# DART SERVICE INSTRUCTION

TO AMEND INSTALLATION INSTRUCTIONS IIN-D407-728 REV. A AND INSTRUCTIONS FOR  
CONTINUED AIRWORTHINESS ICA-D407-728 REV. 0 OR LATER APPROVED REVISIONS

REF. TCCA STC: SH05-44  
REF. FAA STC: SR02200NY  
REF. EASA STC: EASA.IM.R.S.01187

**FIGURE 1 - TRIMMING OF D3340-7 SKIDTUBE PROTECTOR**

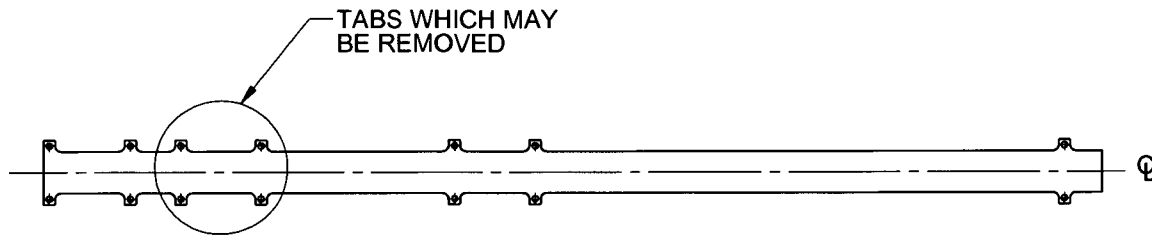
The purpose of this Dart Service Instruction is to permit removal of some tabs on the D3340-7 Skidtube Protectors that are part of the D407-728-411 Skidtube Protector Kit. The tabs that may be removed do not line up with existing holes in the Bell skidtube P/N's 407-011-201 and 407-011-202.

2.1 Trim the tabs not lining up with existing holes in the skidtubes per Figure 1.

2.2 Touch up finish on D3340-7 Skidtube Protectors per Chapter 5.1 of ICA-D407-728 Rev. 0.
